ENGINE – MAIN GEARBOX ASSEMBLY – REWORK THE IDG HOUSING ASSEMBLY AND THE RADIAL GEAR SUPPORT ASSEMBLY TO IMPROVE CLEARANCE REQUIREMENT – CATEGORY CODE 6 – MOD.ENG-72-0012

V2500-ENG-72-0012

Rework the ribs of the IDG drive housing
Fig.1

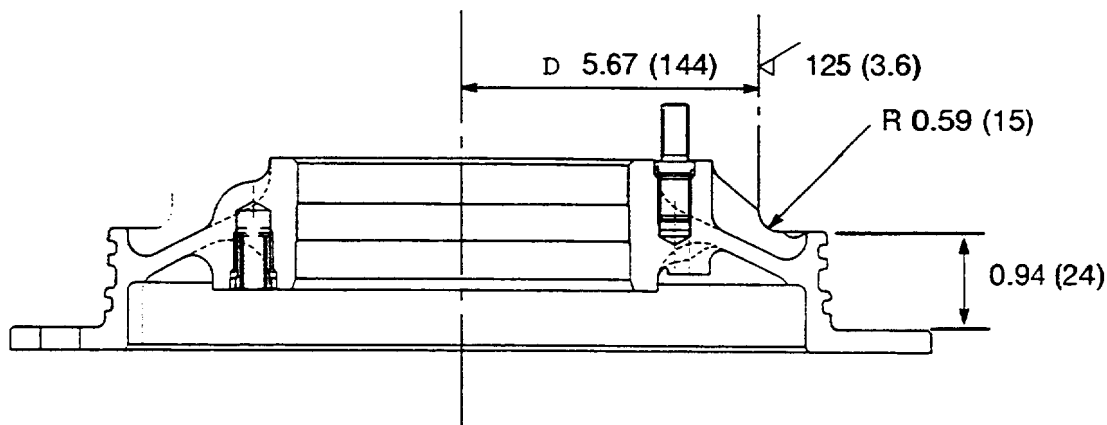
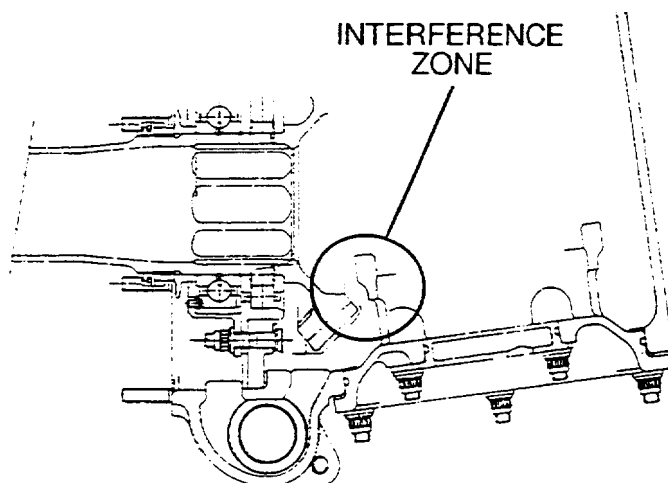
- (a) Interference may occur between the ribs of the IDG drive housing and the support of the main gearbox.
- (b) Interference may occur between the oil shroud of the bevel gear and the support of the radial gear.

- Material has been removed from the ribs of the IDG drive housing.
- Material has been removed from two bosses of the radial gear support.

- (1) Remove the IDG housing. Refer to the approved procedure in Reference (1).
 - (a) Rework the IDG drive housing ribs (3 off) as shown in Figure 1.
- (2) Remove the radial gear support. Refer to the approved procedure in Reference (2).
 - (a) Rework the radial gear support as shown in Figure 2.

- NOTE: - MARK 4B0271 AND CROSS OUT 4B0161
- PROTECT MARKING WITH RESIN VERNISH
USE CoMat 07-050
- TOUCH UP THE REWORKED AREAS.
USE CoMat 07-028
